September 19, 2025

## **ADDENDUM NO. 1**

### **DNR-250004 GREAT COUNCIL OBSERVATION TOWER**

1587 US-68,  
Xenia, OH 45385

5 DOMESTIC ISOMETRIC

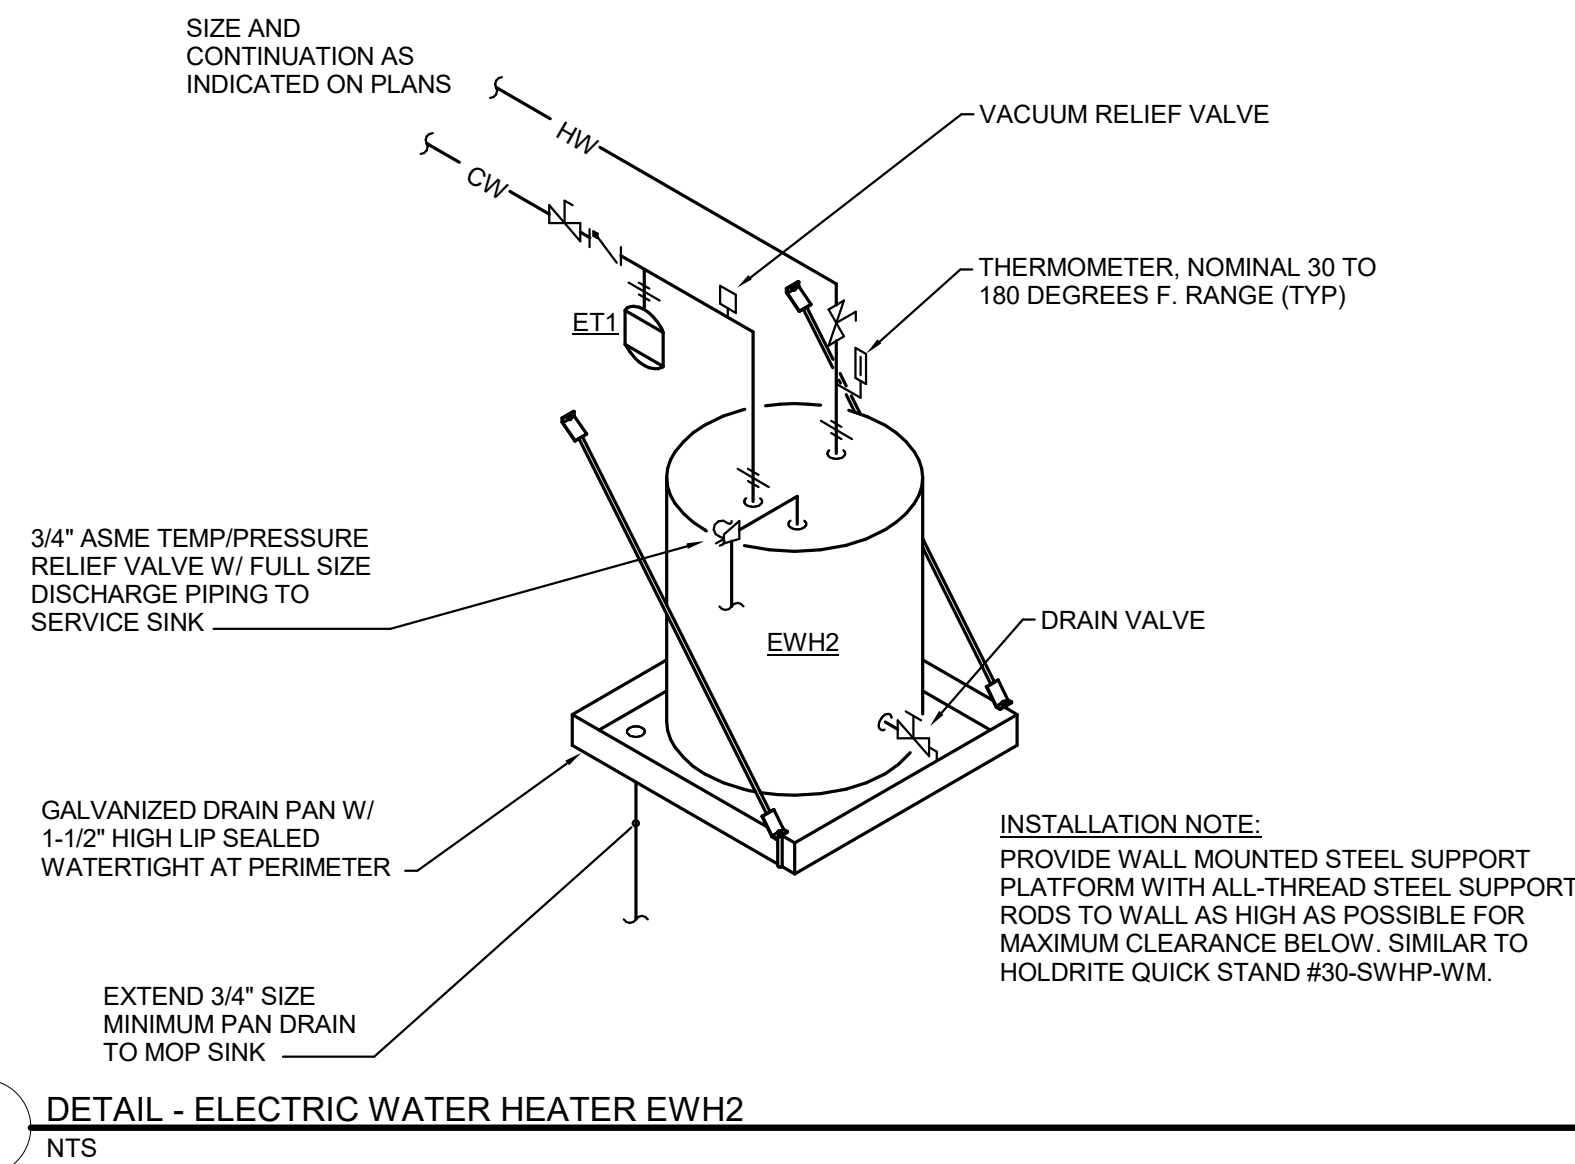
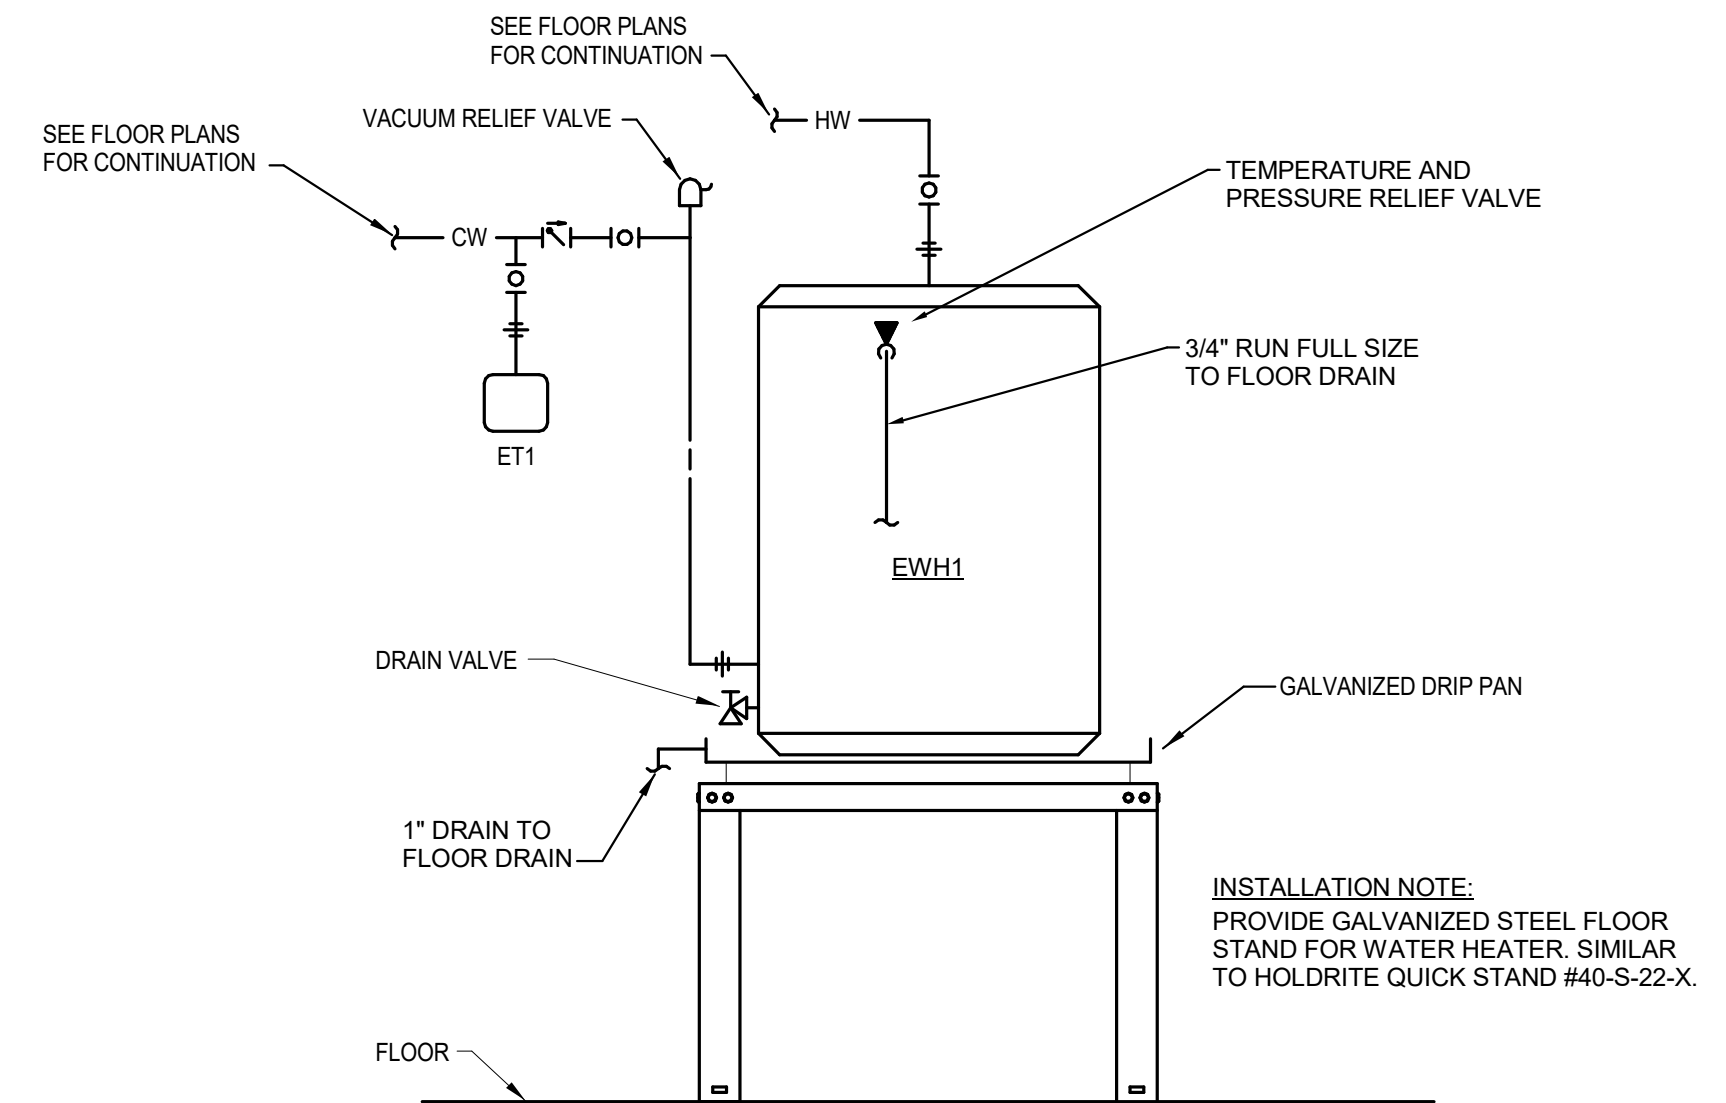
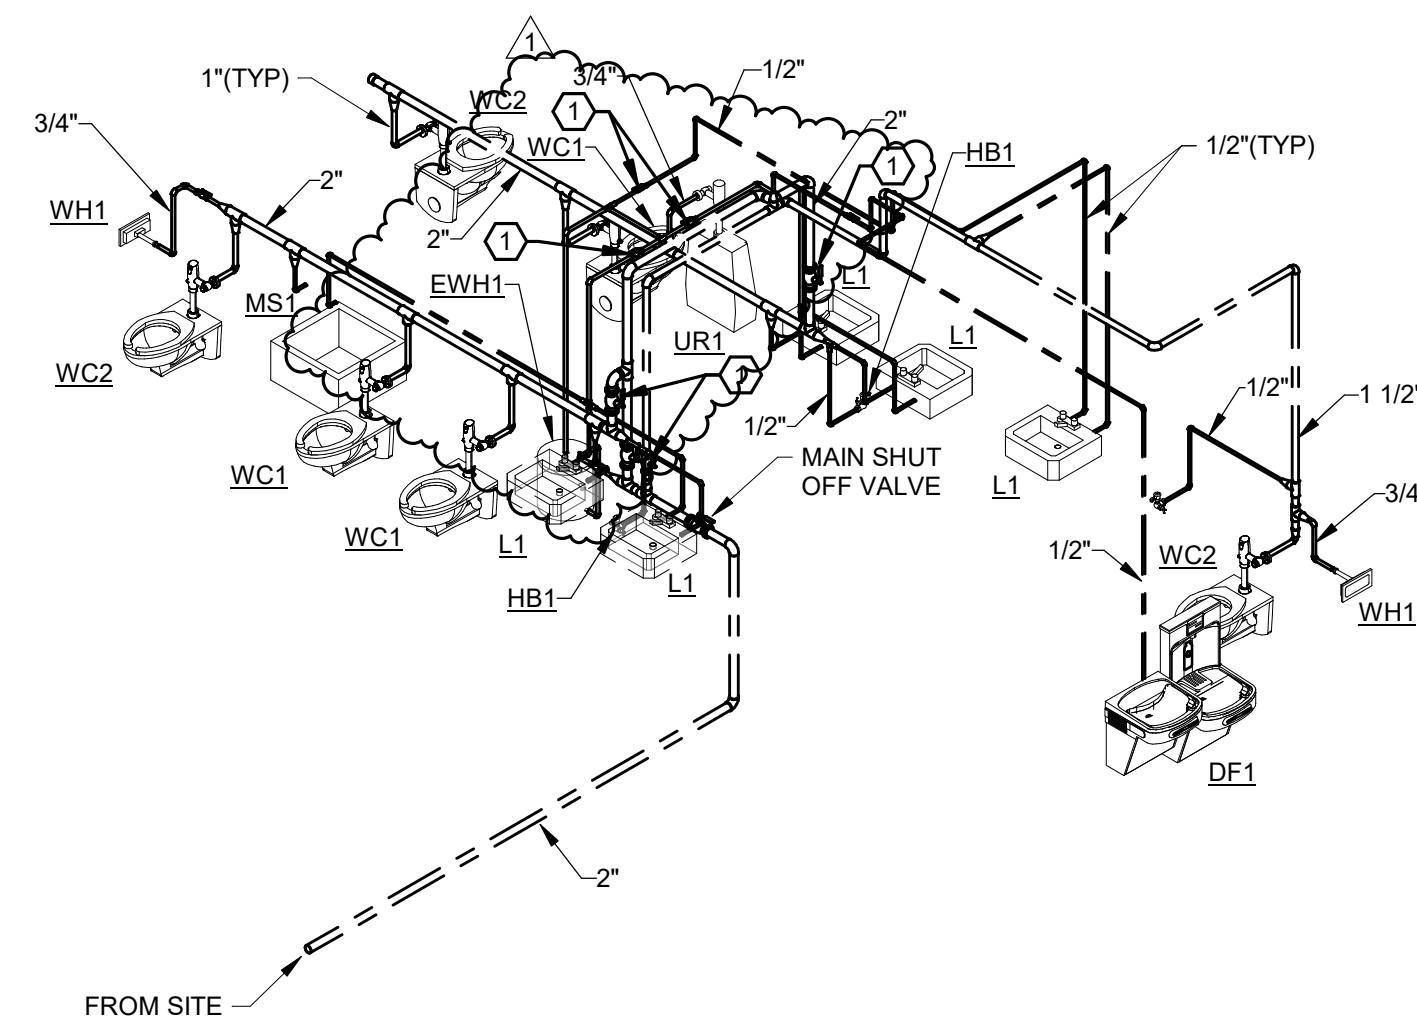
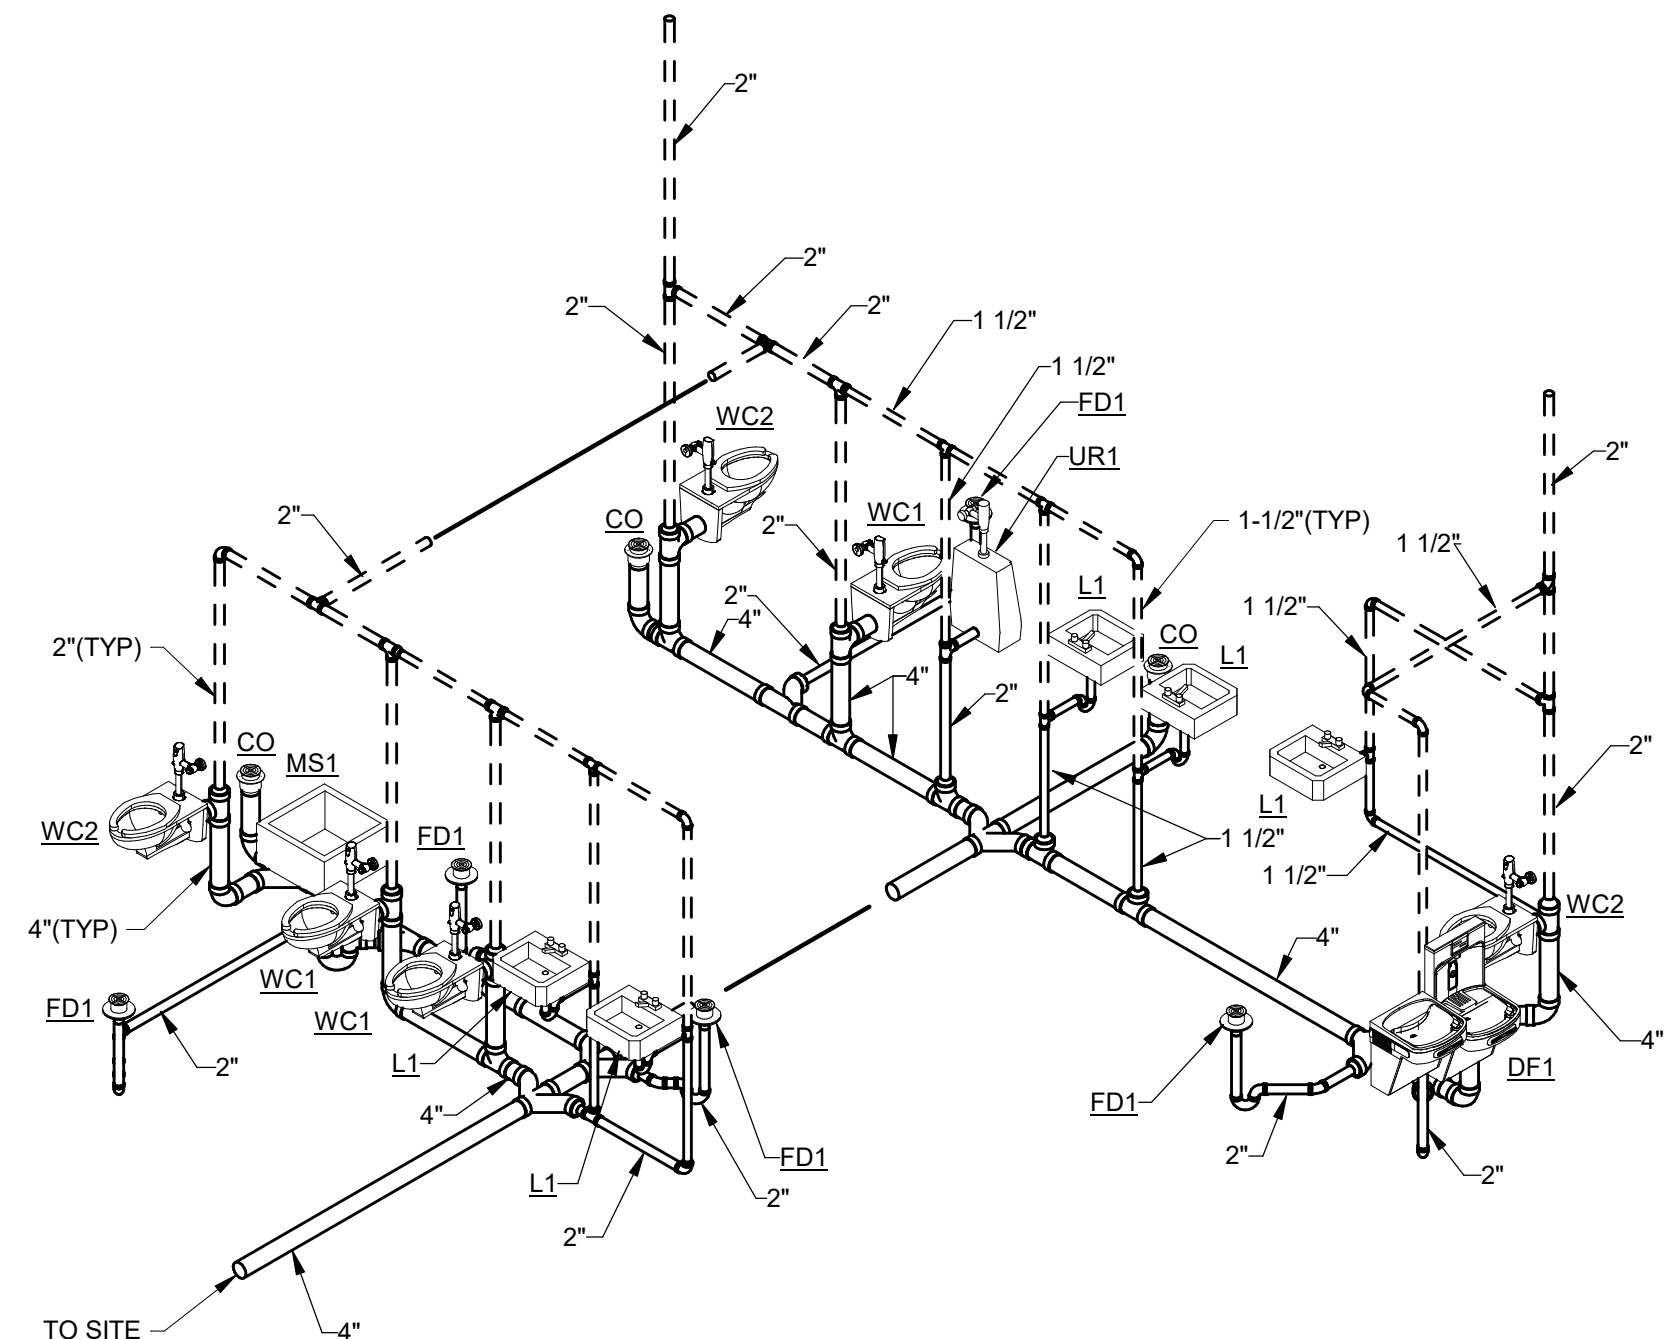
### **ITEM 15 P101 – FIRST FLOOR PLAN PLUMBING**

Added General sheet note to read, "IT IS THE DESIGN INTENT THAT EACH RESTROOM'S WATER SUPPLY SHALL BE ABLE TO BE SHUT DOWN INDEPENDENTLY FOR WINTERIZATION. PROVIDE SHUT OFF VALVES AND AIR COMPRESSOR FITTINGS AS NECESSARY."

Revised Domestic Isometric 5.
